XC3S200 FPGA Errata and Deviations from Spartan-3 Data Sheet

DS099-E03 (v2.3) January 28, 2005

Errata Notice

Figure 3: Requirements when VCCINT is not the Last Supply

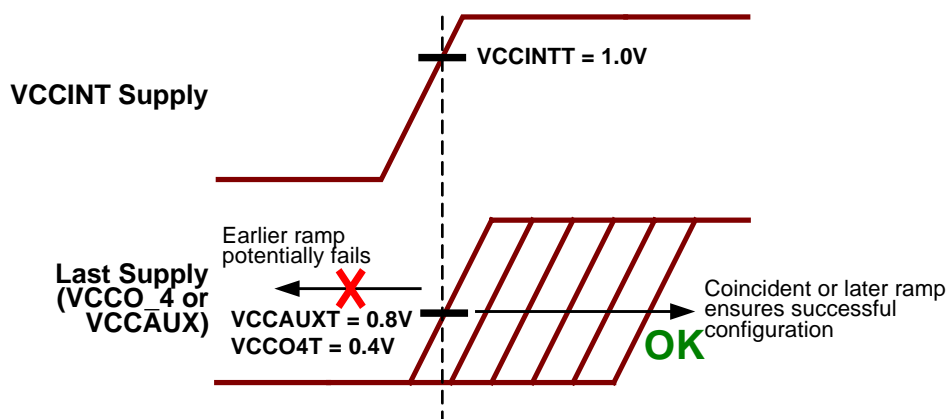
In the potentially failing condition, the VCCINT supply must be the last supply to reach its valid POR voltage and the ramp rate must be slower than 500 μ S. When the FPGA fails to configure, the INIT_B remains Low and the FPGA ignores the PROG_B program pin. Even with the worst identified power sequence, actual failures only occur on a small percentage of devices, typically measured in parts per million. The issue is more pronounced at cold temperatures.

Use a power-on sequence where VCCINT is not the last supply to reach its POR threshold level.

VCCINT must reach its maximum POR threshold ($VCCINTT = 1.0V$) before or coincident with VCCAUX reaching its minimum threshold ($VCCAUXT = 0.8V$). This supply sequence and threshold relationship is illustrated in [Figure 3](#).

Alternatively, VCCINT must reach its maximum POR threshold ($VCCINTT = 1.0V$) before or coincident with VCCO_4 supplying I/O bank 4 reaching its minimum threshold ($VCCO4T = 0.4V$). This supply sequence and threshold relationship is also illustrated in [Figure 3](#).

Figure 4: Use Faster VCCINT Ramp Rate if VCCINT is Last Supply

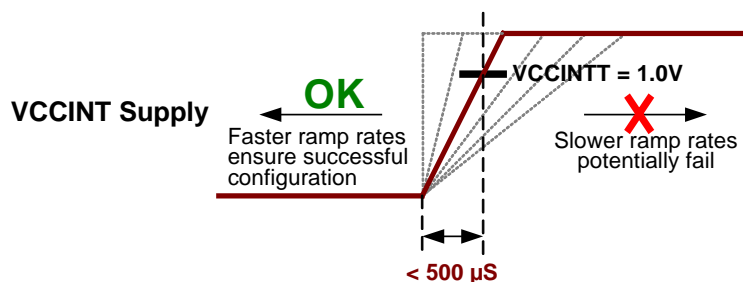
In a system that requires that the VCCINT supply is last in the power-up sequence, ensure that it ramps to its maximum POR threshold voltage ($VCCINTT = 1.0V$) in less than $< 500 \mu$ S, as shown in [Figure 4](#).
